1 **ADDENDUM NO. 1**  
2 **ISSUE DATE: August 12, 2024**

3  
4  
5 **RE: PRIMATE CENTER BACK-UP GENERATOR**  
6 **University of Wisconsin – Madison**  
7 **Madison, Wisconsin**  
8 **MSN Project No. 0526-1703**  
9 **UWSA Project No. A-17-033**

13  
14 **FROM: Mead & Hunt, Inc.**  
15 **2440 Deming Way**  
16 **Middleton, WI 53562**

Sheet Title:  
 UTILITY & GENERATOR ROOM DEMOLITION PLANS

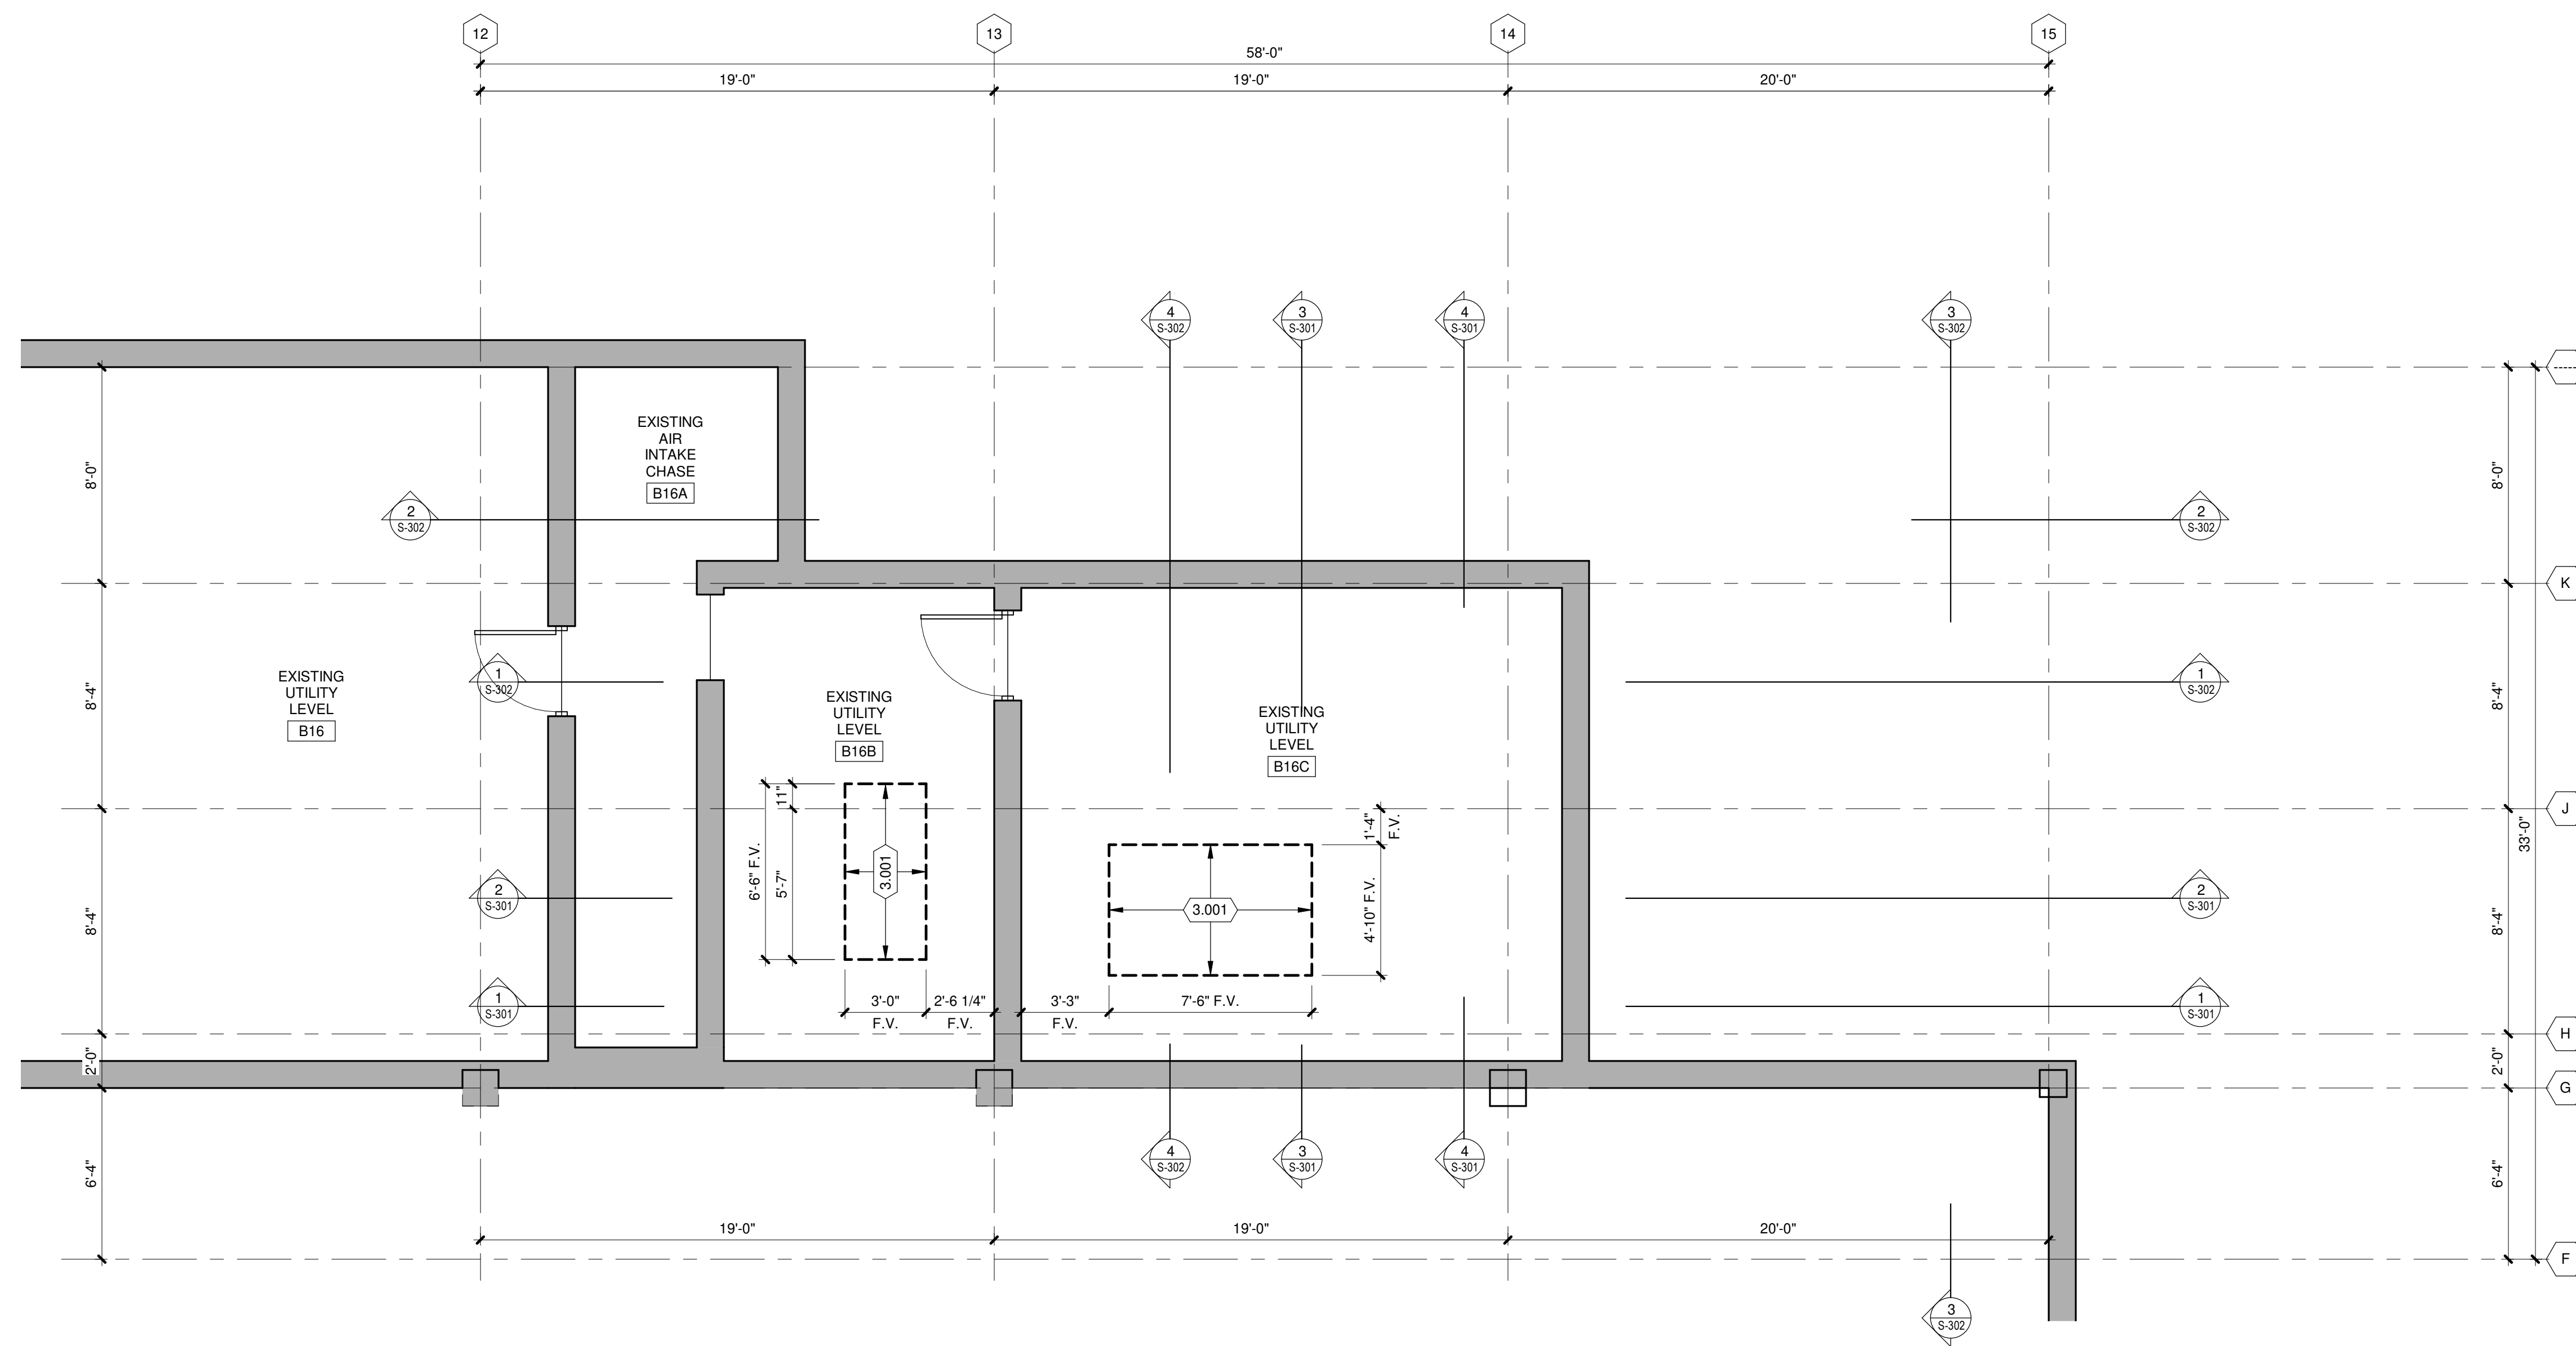
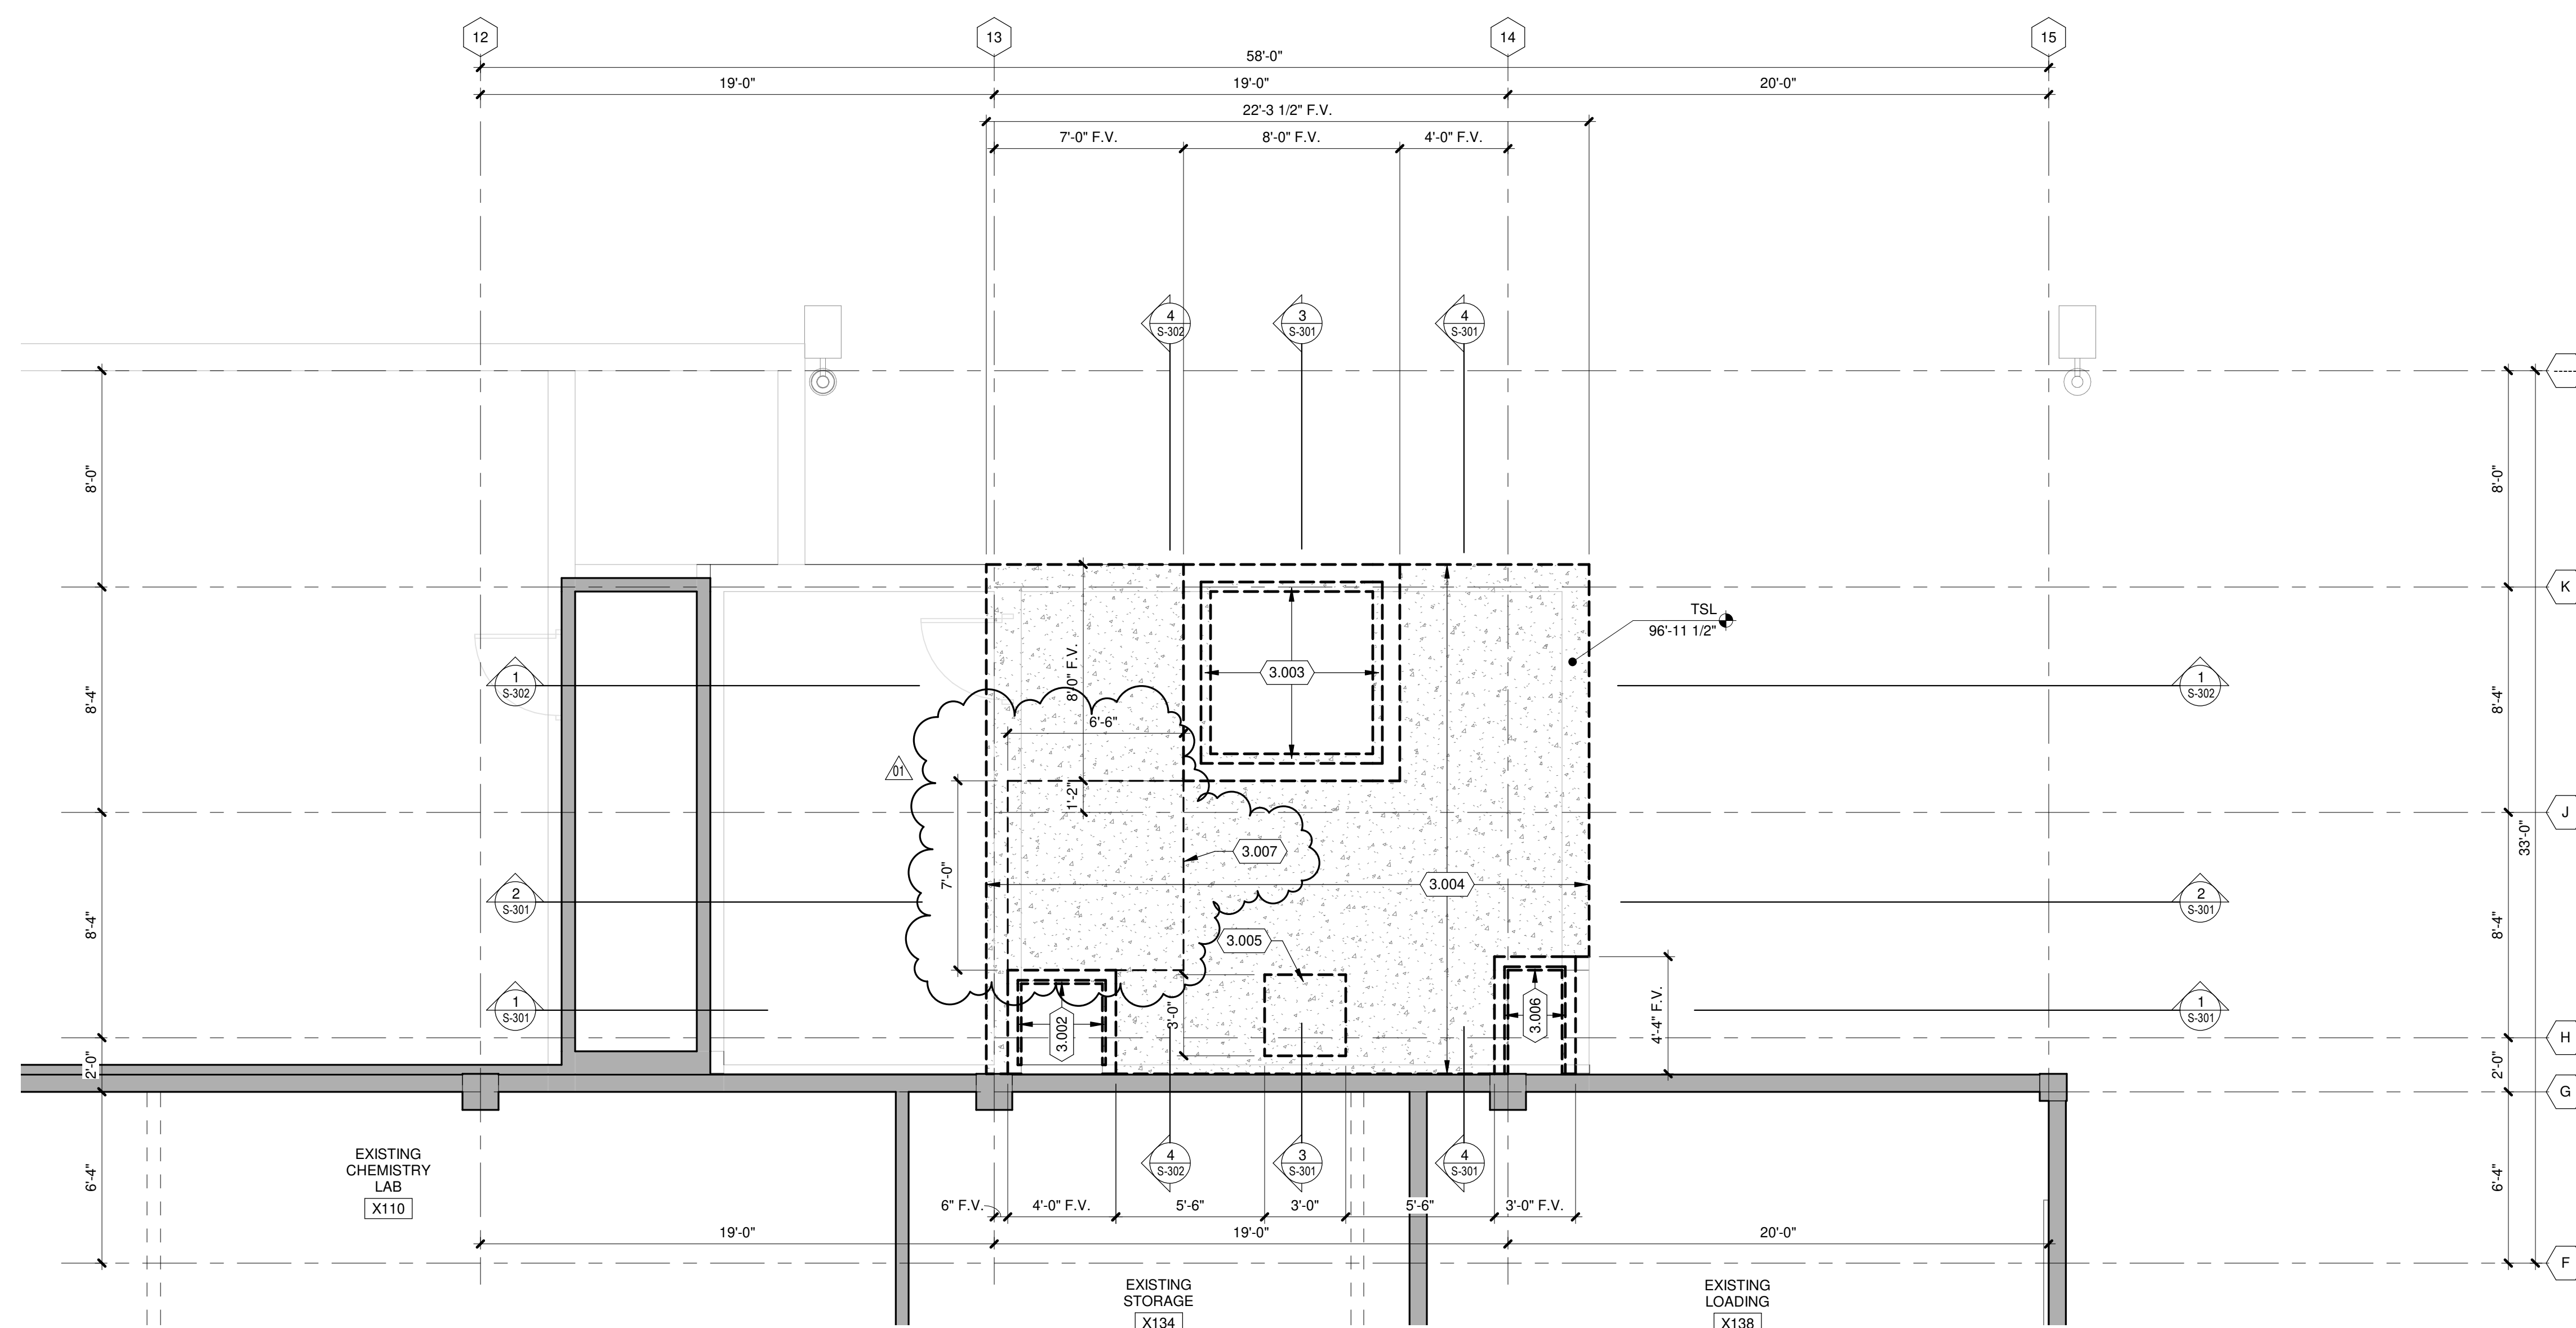
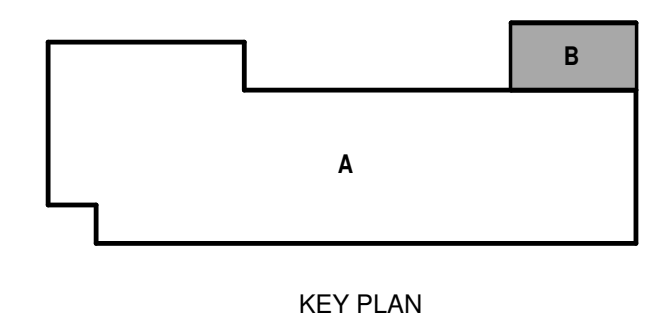
5 1. SHEET SD101: UTILITY & GENERATOR ROOM DEMOLITION PLANS

6 a. Revise as shown clouded within attached sheet SD101.
